Columbia Apparels Ltd - Extension

228/1 Tin Sharak, Joydevpur

6 November 2024

2. Observation

Unbraced racks on the floor

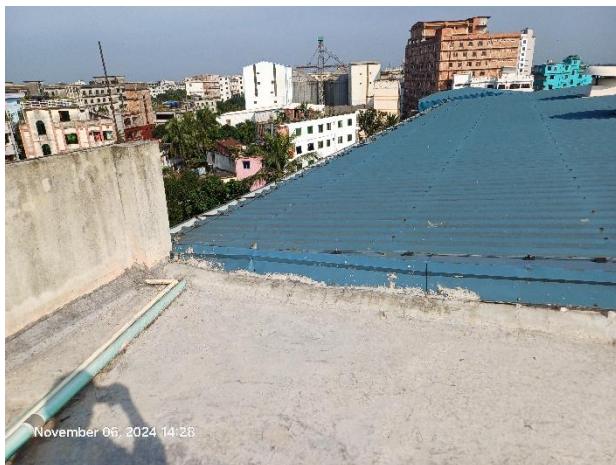
Observation-3: Non-structural elements found unbraced/not anchored. (Factory Building (Extended Portion))

Description: Non-structural elements suspended from, attached to, or resting atop the structure shall be adequately anchored and braced to resist earthquake forces. Factory is required to brace/anchor all non-structural elements (storage racks).

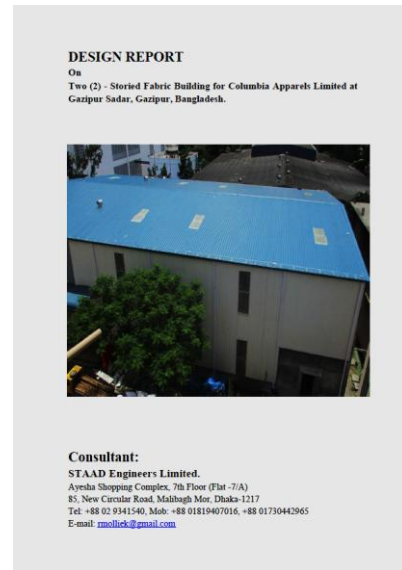
Observation-6: Connection gap. (Fabric Warehouse)

Description: Connection gaps were observed in the steel joint. The building engineer is required to identify the locations and carry out suitable remedial works.
